UNITED STATES  
NUCLEAR REGULATORY COMMISSION  
WASHINGTON, D. C. 20555

SUMMARY OF MEETING HELD ON MAY 13, 1976 WITH REPRESENTATIVES OF THE MARK I  
OWNERS GROUP

DESCRIPTION OF  
SHORT TERM PROGRAM  
PLANT UNIQUE TORUS SUPPORT SYSTEMS  
AND ATTACHED PIPING ANALYSIS

FIGURE 4.2-2 Criteria for Upward Load

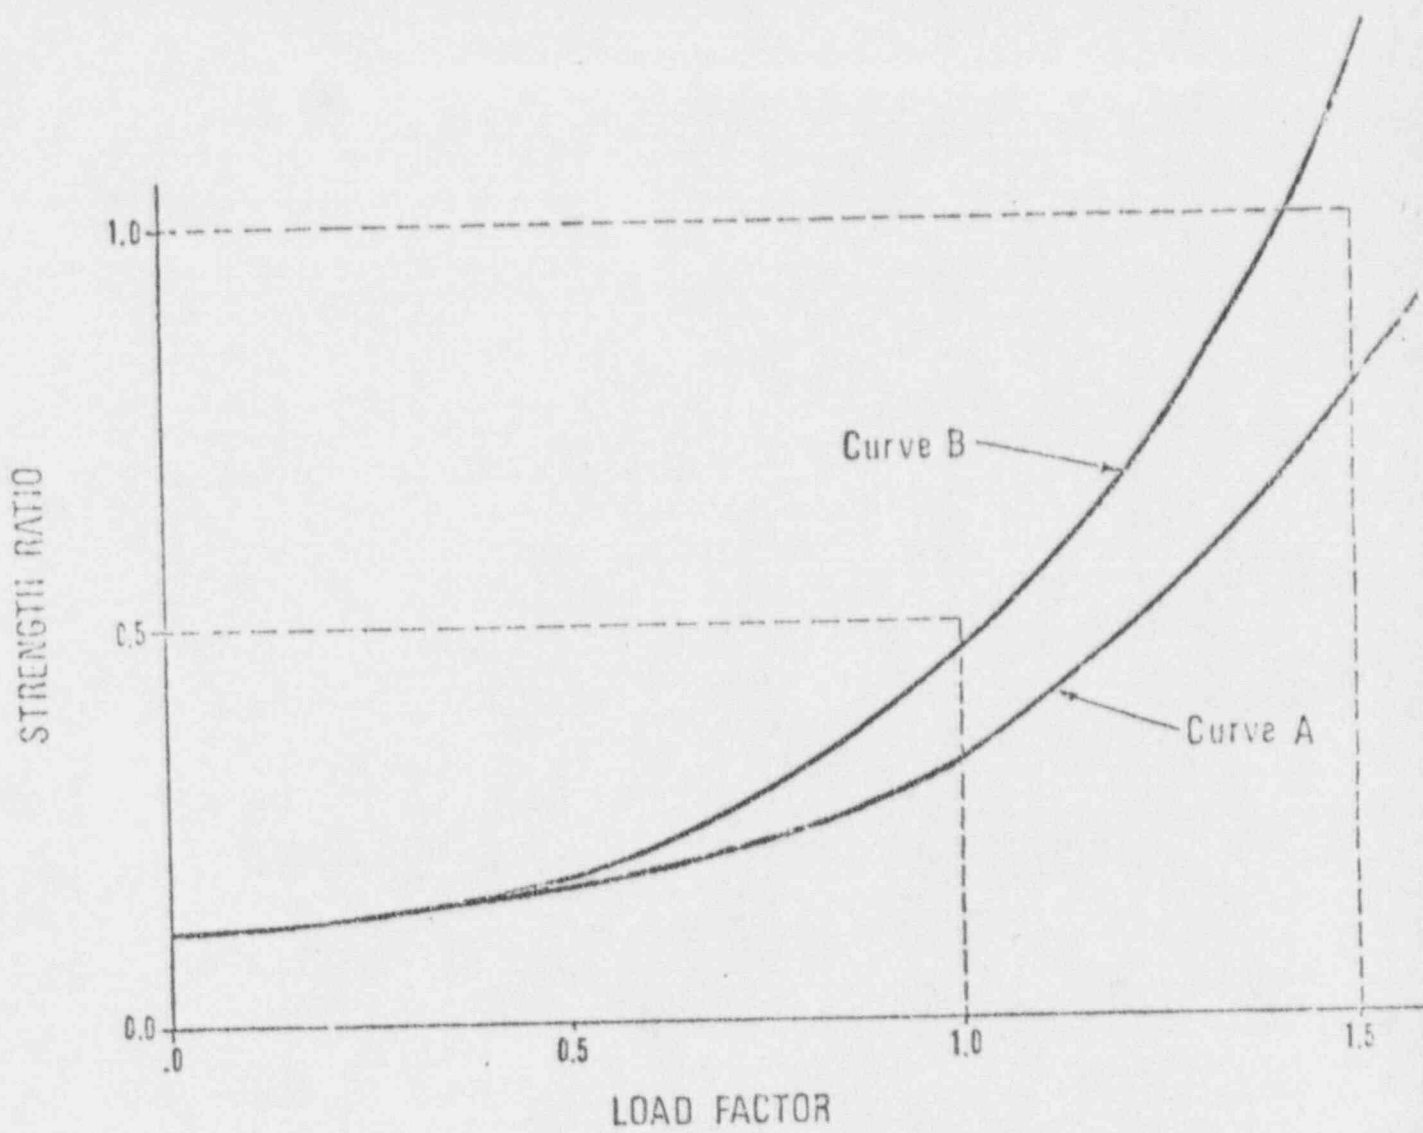
- b. With respect to the plant unique sensitivity analysis for upward loads, the NRC staff requested that GE investigate the effects of applying the load factor (LF) to the entire pressure-time history curve (i.e., to both the downward and the upward segments of the curve) in addition to applying the LF to the upward force segment of the curve alone.
